Town of Kittery Planning Board Meeting September 14, 2023

ITEM 3—120 US Route 1—Site Plan — Preliminary Review

**RE: Town of Kittery, Planning Board Services
139 Old Post Road, 112 & 120 US Route 1
Traffic Impact Study Review
Tax Map 14, Lots 10, 12, & 12A
CMA #591.160**

Re: Response to Traffic Impact Study Review
Proposed Extended Stay Hotel - 139 Old Post Road, 112 & 120 US Route 1 Bypass
Kittery, Maine

SITE PLAN
 SCALE: 1"=20'
 PROJECT NO. NEX-2200380
 7 OF 18

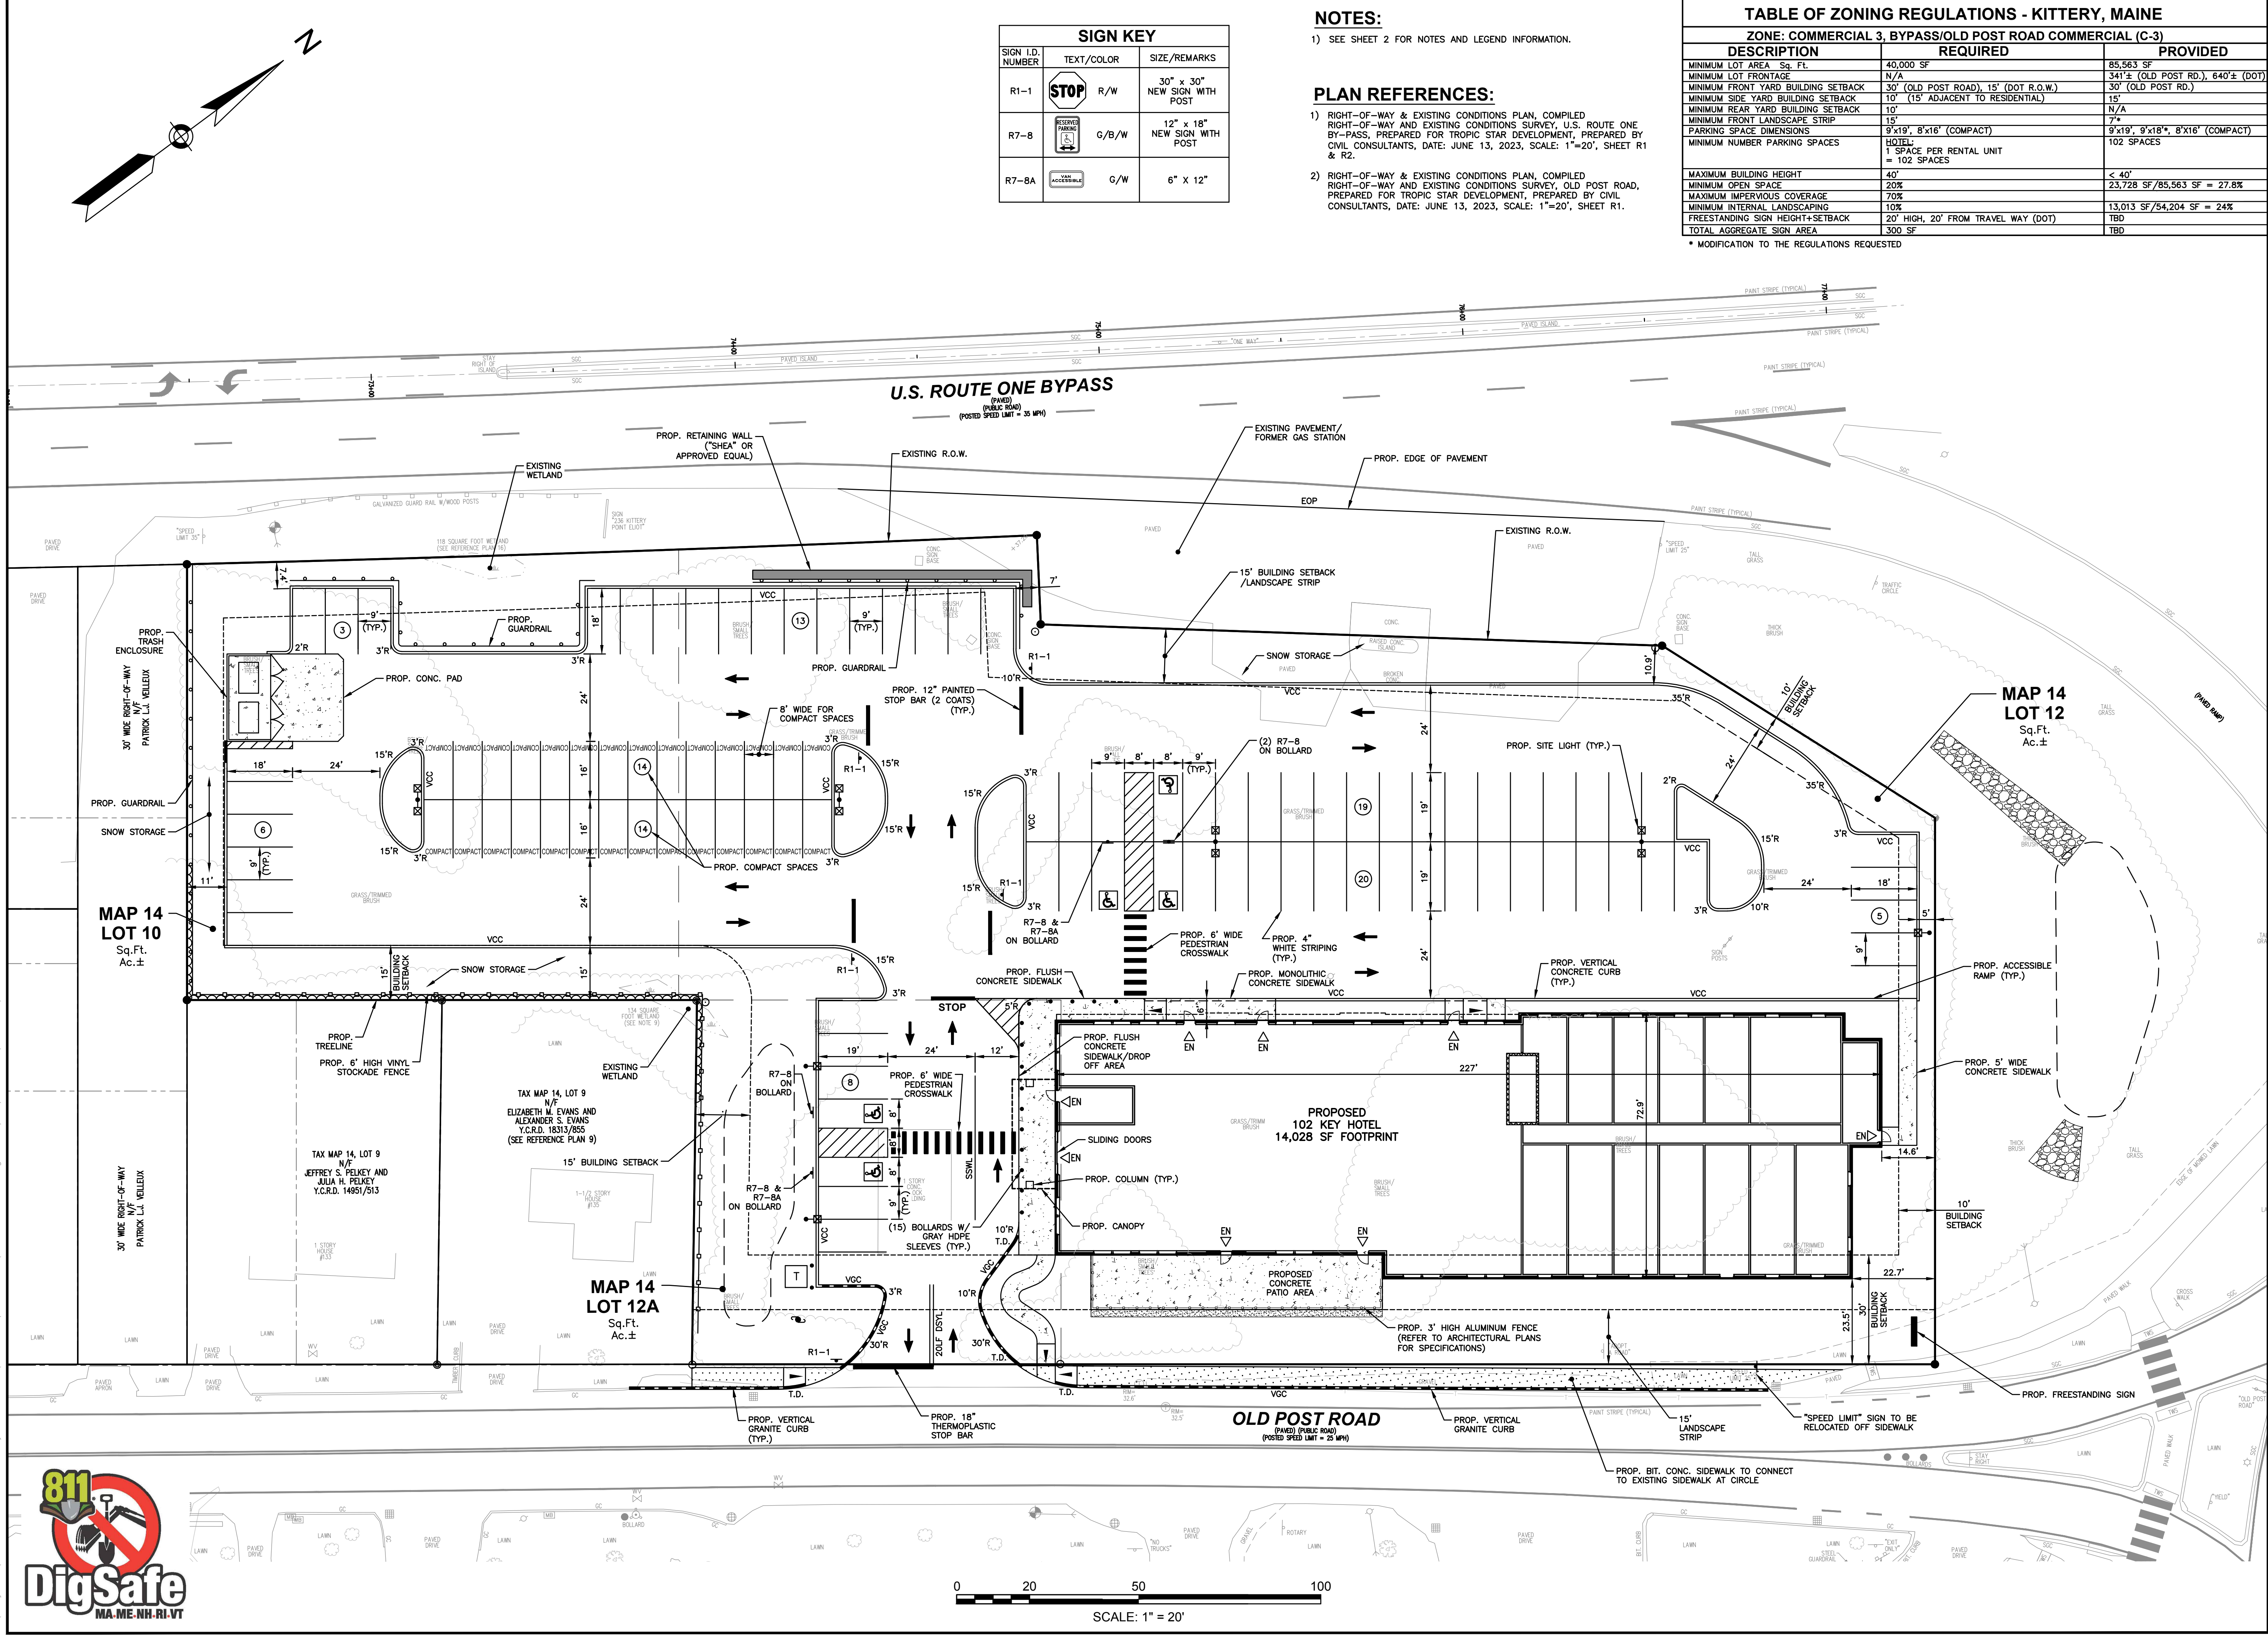
The new proposal would likely increase impervious surface above the maximum allowable of 70%; to approve the new site plan, the applicant would need to receive a modification of impervious surface requirements; if the board is not amenable to modifying a zoning standard, staff suggest modifying parking requirements (which would reduce the impervious surface on the lot) as a possible workaround. The revised site plan has delayed completion of the required third-party engineer review of the site plan and drainage analysis, but the changes did not impact the review of the traffic analysis, completed on September 6th and included in this packet.

3. Wastewater staff have confirmed with the applicant that the sewer easement will allow the proposed development to connect to existing infrastructure and confirmed adequate capacity of wastewater systems. The provided sewer utility plan shows pipelines outside of the indicated easement area; unless approved by the wastewater department, future iterations of the plan must site all proposed sewage pipeline within the indicated easement.

§16.5.10	Essential Services	A sewer easement has been provided; however, the utility plan appears to show the proposed sewer line would be constructed outside of the easement area. Wastewater staff have not approved the

§16.7.11.F.(e).	A minimum of 102 parking spaces are required	The plan appears to only have 101 spaces in the site plan. When notified, the applicant said they would amend the site plan at a later stage to add the single required parking space. The plan appears to meet ADA space requirements
Code Ref.	§16.7.10 Preliminary Site Plan Requirements	
	Standard	Determination
§16.7.10.C.(4).(a-i).	<ul style="list-style-type: none"> • Paper plan sheets no smaller than 11” x 17” • Scale of drawing no greater than 1 inch = 30 feet • Code block in right-hand corner • Standard boundary survey of existing conditions • Compass with arrow pointing true north • Locus map of property • Vicinity map and aerial photograph • Surveyed acreage of parcel(s), rights-of-way, wetlands, and amount of street frontage • Names and addresses of owners of record abutting property 	Provided

SIGHT DISTANCE STUDY PLAN

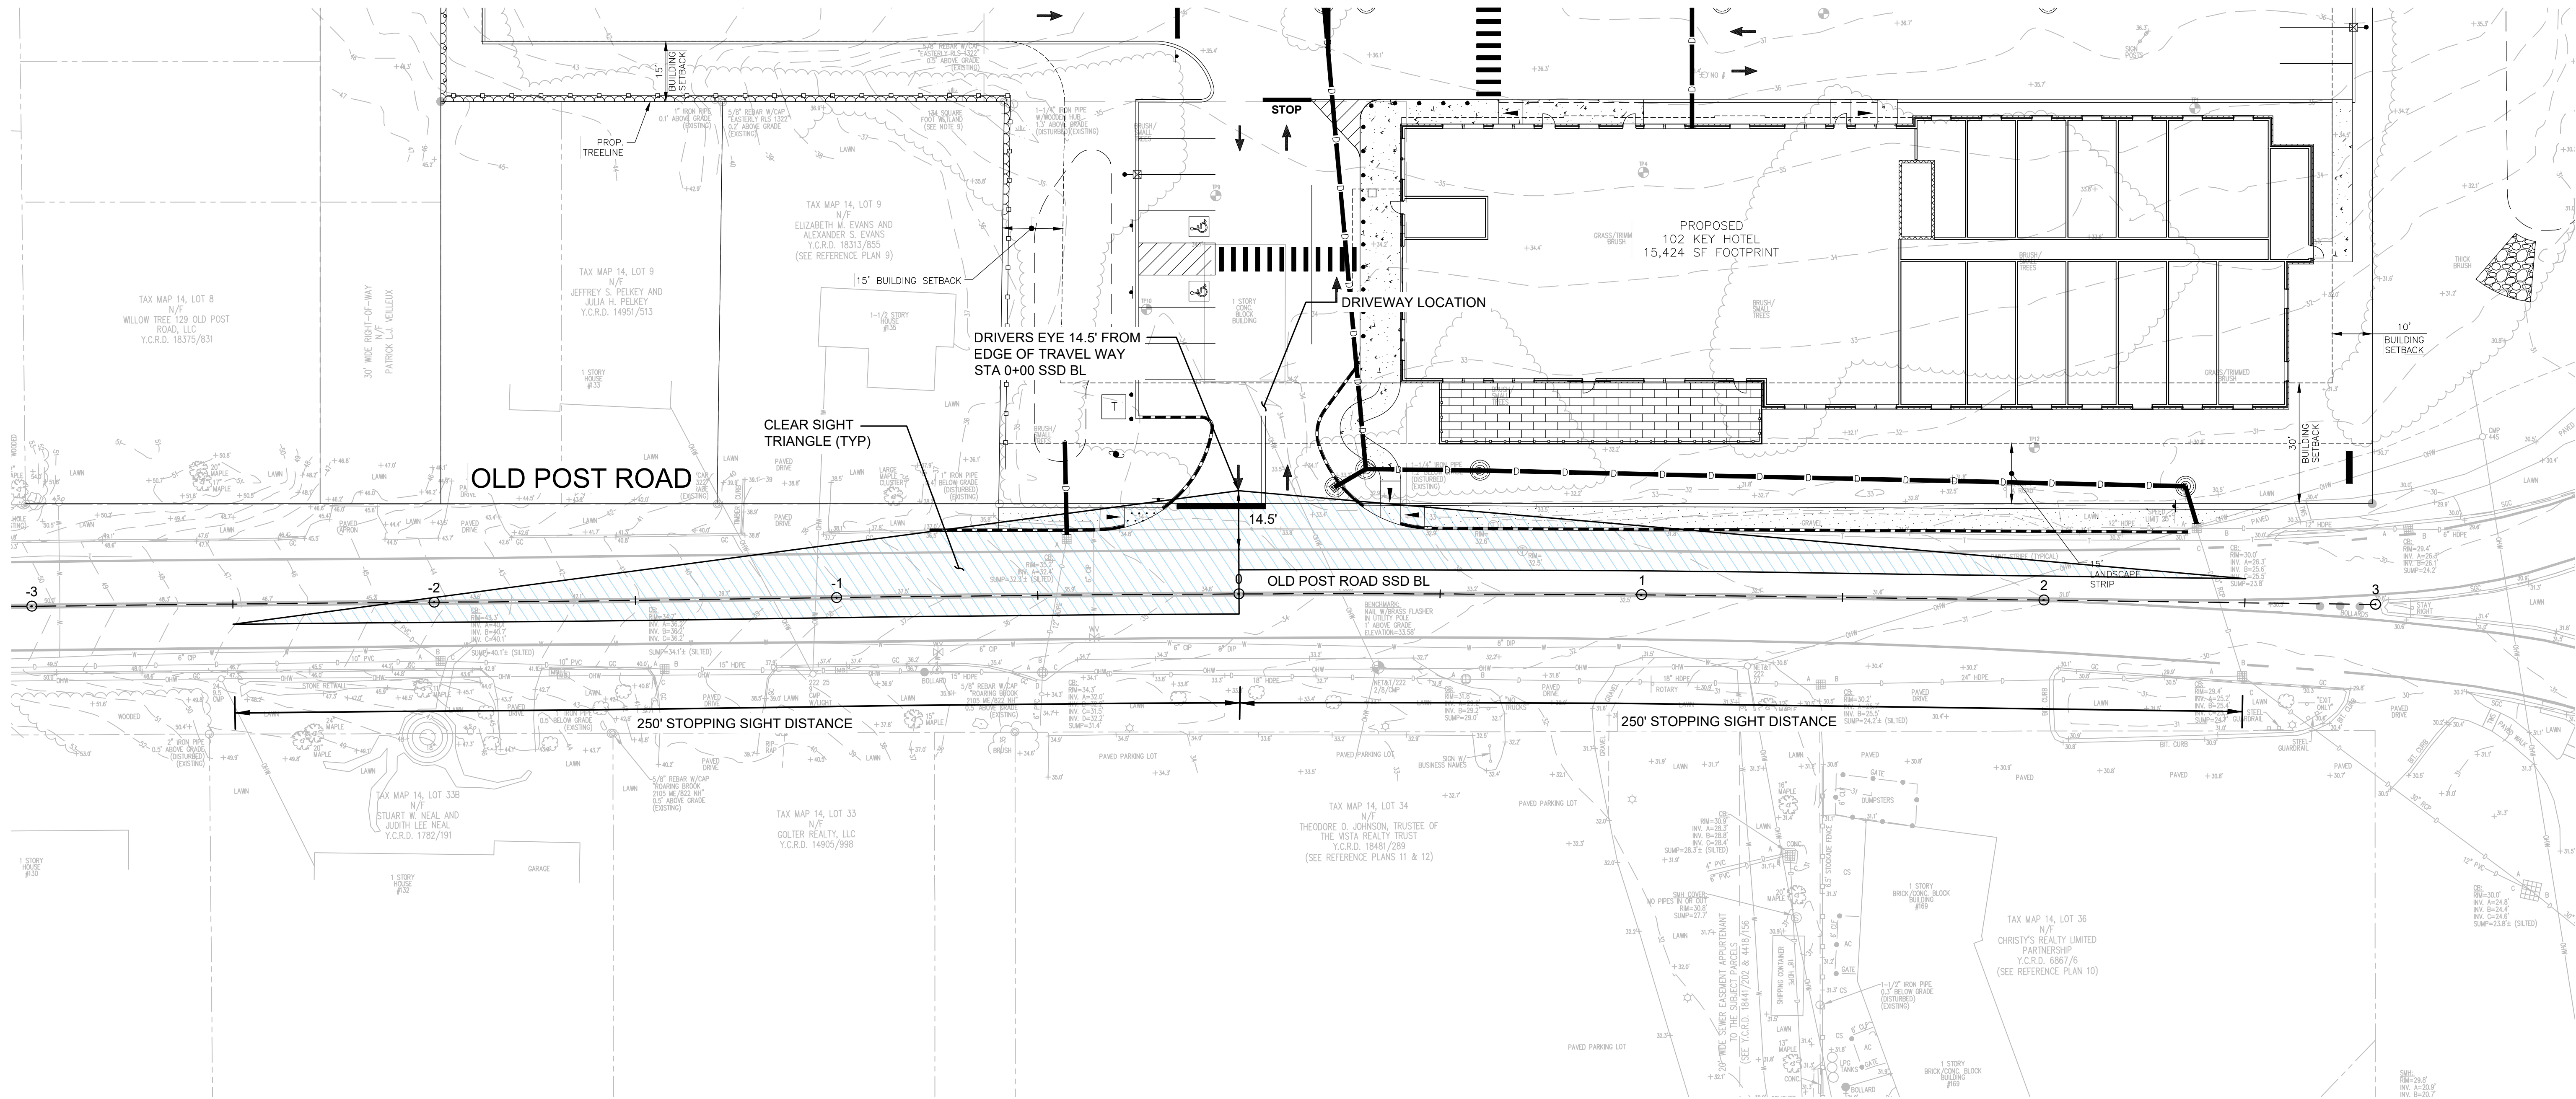
Comment 5. The traffic impact study notes the sight distance is substandard (150’ less than desired) looking south from the site driveway without clearing trees/vegetation. The applicant shall confirm they have control over the area that needs to be cleared and show the required sight triangle on the site plans.

Response: The sight triangles have been added to the Site Plan and illustrate that the subject areas are located within the Project site or the public right-of-way along Old Post Road. As such, the recommended trimming/removal of vegetation within the sight triangle areas can occur with the requisite permits and approvals from the Town.
